Subject: RUST ON FRONT DOOR QUARTER GLASS AT BELTLINE MOLDING	Bulletin No.: 09-011/19
	Last Issued: 02/25/2019

APPLICABLE MODEL(S)/VINS

2016-2019 MX-5 with VINs lower than JM1ND*****304583 (produced before December 19, 2018)

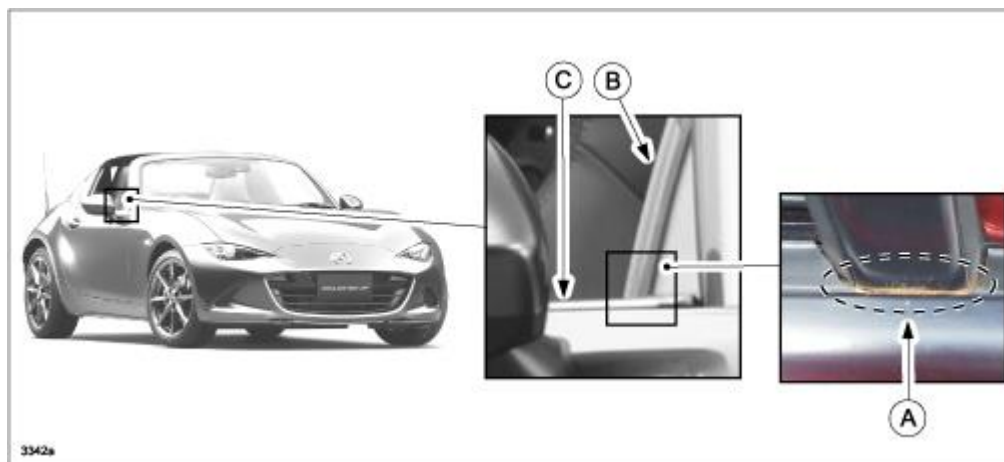
Some vehicles may exhibit rust (A) on the front door quarter glass guide (B) where it contacts the door beltline molding (C). The paint on the quarter glass guide gets damaged from vibration when the door is closed and when driving.

This concern is caused by the beltline molding contacting the quarter glass guide due to production variances. To correct this concern, a spacer has been attached at the contact area to assure an appropriate clearance between the beltline molding and the quarter glass guide.
Customers having this concern should have their vehicle repaired using the following repair procedure.

REPAIR PROCEDURE

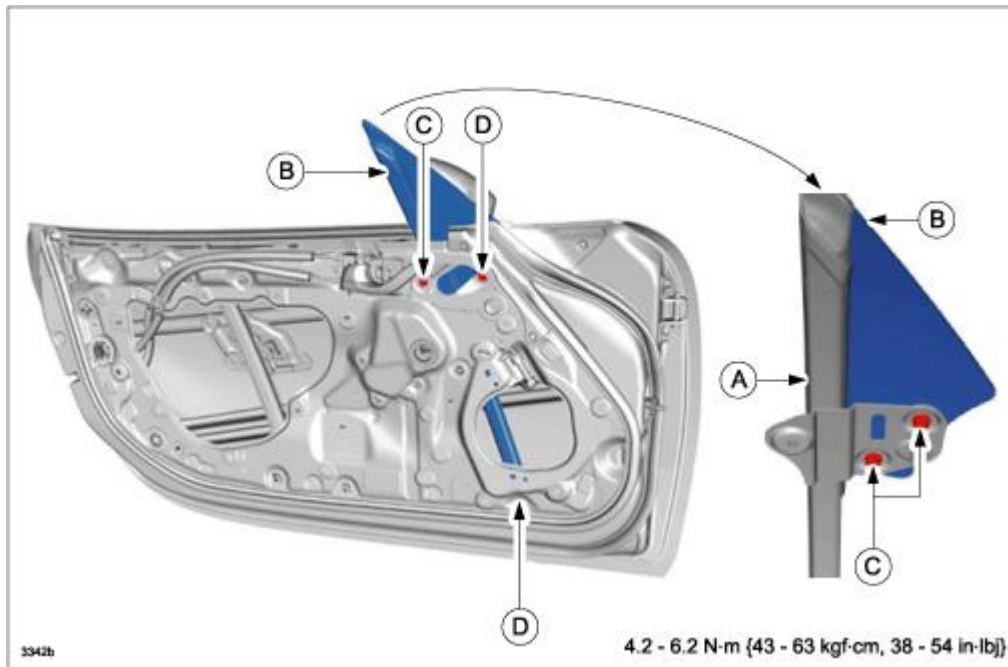
1. Verify the customer concern.
2. Replace the affected side front beltline molding(s) with a modified one(s) according to the procedure "FRONT BELTLINE MOLDING REMOVAL/INSTALLATION" on MGSS .
3. Replace the affected side front door quarter glass guide(s) (A) on the door quarter glass (B) with a new one(s) according to the procedure "DOOR QUARTER GLASS REMOVAL/INSTALLATION" on MGSS. (C: Bolt, D: Nut)
